## Descriptive Report to Accompany Hydrographic Survey H-11454

## Sheet C

## July 29 - August 15, 2005

## Terra Surveys, LLC

Figure 2: The junction location of H11453 and H11454 (Chart 16206, 7<sup>th</sup> Ed.)

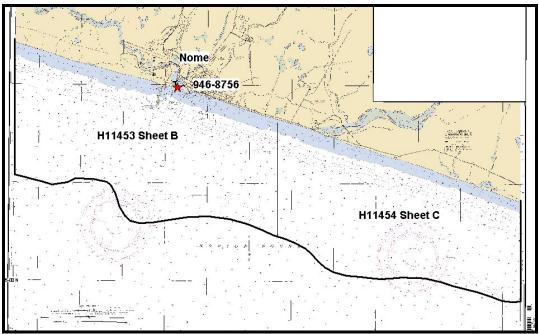
The westerly limits of this survey junctions the easterly limits of H-11453 (2005, Scale 1:10,000) (see *Figure 2.*). There is good agreement between the soundings in the two surveys.<sup>4</sup>

<sup>4</sup> Concur

Caris Base Surface overlay with chart 16206 7th Ed

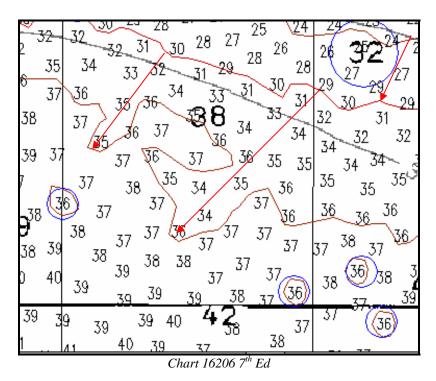
In the vicinity of Latitude N 64° 28' 46", Longitude W 165° 19' 50", contours are migrating up to 120 meters seaward and 130 meters shoreward. The hydrographer recommends updating Chart 16206 with current contours and soundings from the H11454 Final Smooth Sheet.<sup>9</sup>

<sup>9</sup> Concur

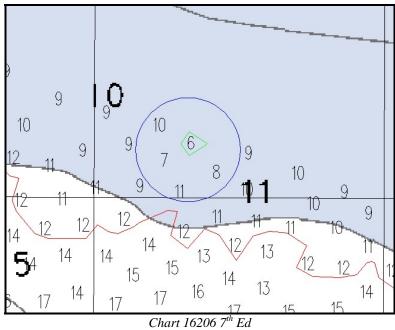
In the vicinity of Latitude N  $64^{\circ}$  28', Longitude W  $165^{\circ}$  17', contours are migrating 100-200 meters seaward, and 2005 soundings reflect four 36 foot contours not previously charted. The hydrographer recommends updating Chart 16206 with current contours and soundings from the H11454 Final Smooth Sheet.<sup>10</sup>

<sup>10</sup> Concur

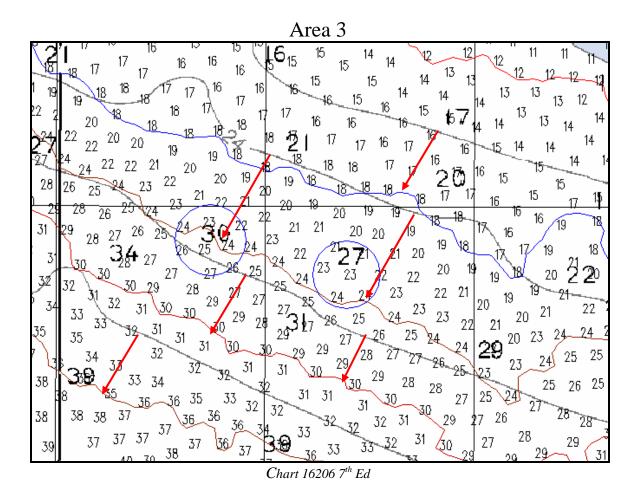
In the vicinity of Latitude N 64° 28' 32", Longitude W 165° 16' 50", there is a six foot contour not previously charted. The hydrographer recommends updating Chart 16206 with current contours and soundings from the H11454 Final Smooth Sheet.<sup>11</sup>

<sup>11</sup> Concur

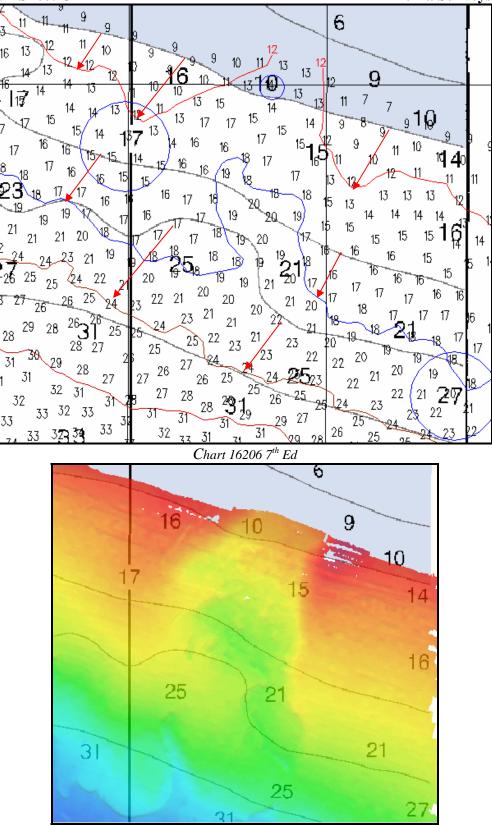
In the vicinity of Latitude N 64° 27' 27", Longitude W 165° 11'28", contours are migrating seaward by 100-250 meters. The Hydrographer recommends updating Chart 16206 with soundings and contours from H11454 Final Smooth Sheet.<sup>12</sup>

<sup>12</sup> Concur

Area 4

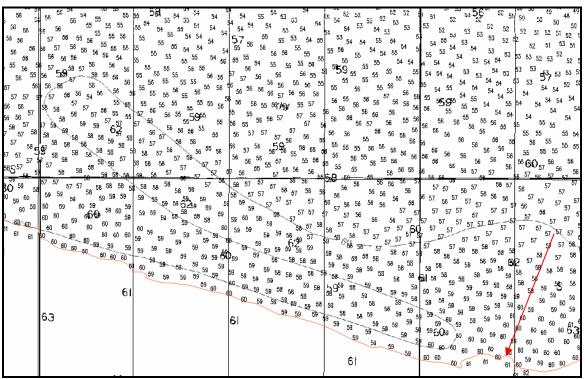
In the southeastern portion of the survey, the 60 foot contour has migrated seaward by as much as 500 meters and 2005 soundings are shoaler by an average of 3 to 5 feet. The Hydrographer recommends updating Chart 16206 with soundings and contours from H11454 Final Smooth Sheet.<sup>14</sup>

<sup>14</sup> Concur

DTON Soundings (Feet) Circled in Red. Chart 16206 7th Ed

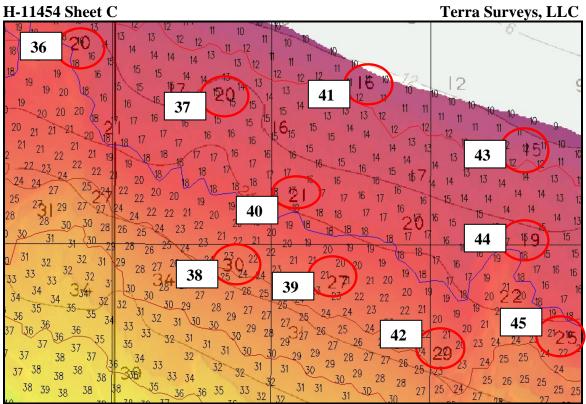
*ID#	Chart Sounding	Latitude (N)	Longitude (W)
28.	31	64° 27' 46.7"	165° 13' 50.8"
29.	43	64° 27' 32.3"	165° 13' 42.3"
30.	29	64° 27' 46.8"	165° 13' 33.3"
31.	23	64° 27' 51.7"	165° 13' 34.5"
32.	15	64° 27' 58.6"	165° 13' 07.5"
33.	22	64° 27' 48.1"	165° 13' 07.9"
34.	28	64° 27' 43.9"	165° 13' 06.7"
35.	21	64° 27' 47.4"	165° 12' 45.7"

The hydrographer recommends updating Chart 16206 with soundings from H11454 final smooth sheet.<sup>20</sup>

<sup>20</sup> Concur

DTON Soundings (Feet) Circled in Red. Chart 16206 7<sup>th</sup> Ed

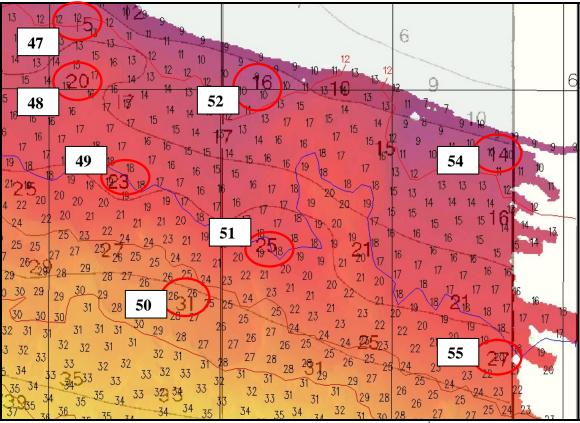
<u>*ID#</u>	Chart Sounding	Latitude (N)	Longitude (W)
36.	20	64° 27' 46.5"	165° 12' 06.1"
37.	20	64° 27' 42.4"	165° 11' 40.4"
38.	30	64° 27' 29.0"	165° 11' 38.0"
39.	27	64° 27' 27.1"	165° 11' 15.9"
40.	21	64° 27' 34.4"	165° 11' 26.1"
41.	16	64° 27' 43.5"	165° 11' 11.9"
42.	29	64° 27' 21.3"	165° 10' 57.6"
43.	15	64° 27' 35.4"	165° 10' 25.1" <sup>21</sup>
44.	19	64° 27' 30.7"	165° 10' 42.3"
45.	25	64° 27' 22.7"	165° 10' 33.8"

The hydrographer recommends updating Chart 16206 with soundings from H11454 final smooth sheet.<sup>22</sup>

<sup>21</sup> Strike <u>64° 27' 35.4"</u> and insert 64° 27' 38.0". Strike <u>165° 10' 25.1"</u> and insert 165° 10' 40".

<sup>22</sup> Concur

DTON Soundings (Feet) Circled in Red. Chart 16206 7th Ed

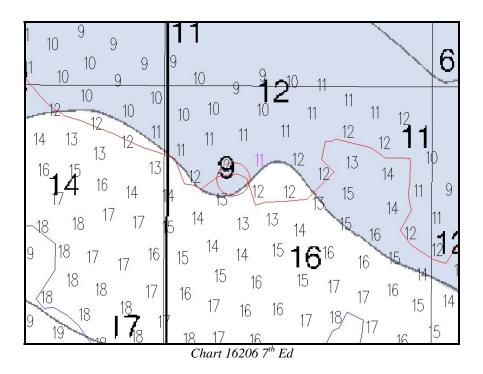
*ID#	Chart Sounding	Latitude (N)	Longitude (W)
47.	15	64° 27' 35.4"	165° 10' 25.1"
48.	20	64° 27' 30.3"	165° 10' 27.0"
49.	23	64° 27' 23.0"	165° 10' 19.5"
50.	31	64° 27' 14.4"	165° 10' 08.2"
51.	25	64° 27' 17.7"	165° 09' 53.0"
52.	16	64° 27' 31.0"	165° 09' 53.7"
54.	14	64° 27' 25.1"	165° 09' 09.5"
55.	27	64° 27' 09.8"	165° 09' 11.2"

The hydrographer recommends updating Chart 16206 with soundings from H11454 final smooth sheet.<sup>23</sup>

<sup>23</sup> Concur

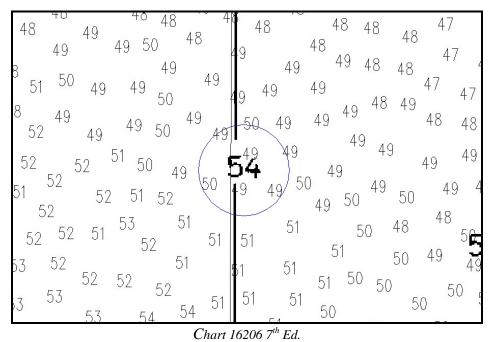
In the vicinity of Latitude N 64° 28' 56", Longitude W 165° 19' 53", the charted 9 foot sounding has 12 foot soundings in the same location. The hydrographer recommends updating Chart 16206 with soundings from H11454 Final Smooth Sheet.<sup>24</sup>

<sup>24</sup> Concur

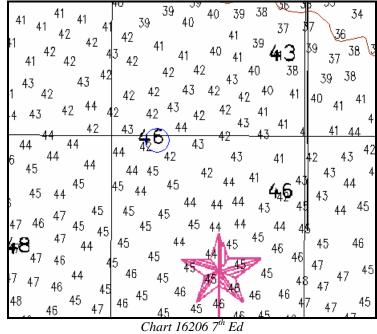
In the vicinity of N 64° 27' 52", Longitude W 165° 19'58", the charted 54 foot sounding has 49 foot soundings in the same location. The hydrographer recommends updating the next chart edition with soundings from H11454 Final Smooth Sheet.<sup>25</sup>

<sup>25</sup> Concur

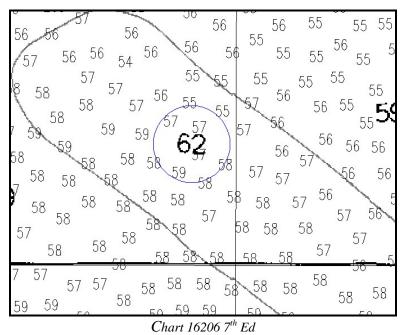
In the vicinity of Latitude N 64° 27' 29", Longitude W 165° 14'25", the charted 46 foot sounding has 42 foot soundings in the same location. The hydrographer recommends updating Chart 16206 with soundings from H11454 Final Smooth Sheet.<sup>26</sup>

<sup>26</sup> Concur

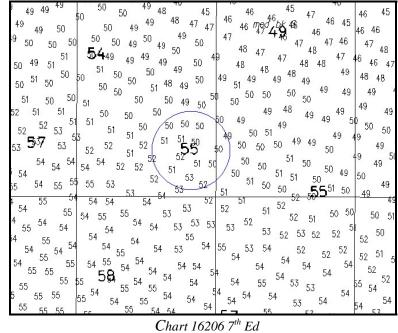
In the vicinity of Latitude N 64° 26' 06", Longitude W 165° 11'35", the charted 62 foot sounding has 57 foot soundings in the same location. The hydrographer recommends updating Chart 16206 with soundings from H11454 Final Smooth Sheet.<sup>27</sup>

<sup>27</sup> Concur

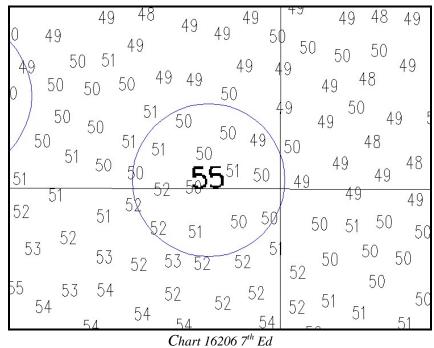
In the vicinity of Latitude N 64° 26' 35", Longitude W 165° 11'04", the charted 55 foot sounding has 50 foot soundings in the same location. The hydrographer recommends updating Chart 16206 with soundings from H11454 Final Smooth Sheet.<sup>28</sup>

<sup>28</sup> Concur

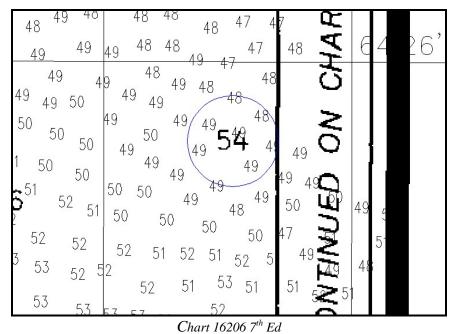
In the vicinity of Latitude N 64° 26' 30", Longitude W 165° 10'39", the charted 55 foot sounding has 50 foot soundings in the same location. The hydrographer recommends updating Chart 16206 with soundings from H11454 Final Smooth Sheet.<sup>29</sup>

<sup>29</sup> Concur

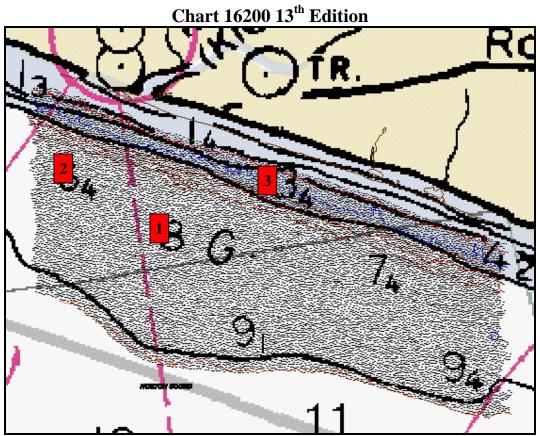
In the vicinity of Latitude N 64° 26' 26", Longitude W 165° 09'14", the charted 54 foot sounding has 49 foot soundings in the same location. The hydrographer recommends updating Chart 16206 with soundings from H11454 Final Smooth Sheet.<sup>30</sup>

<sup>30</sup> Concur
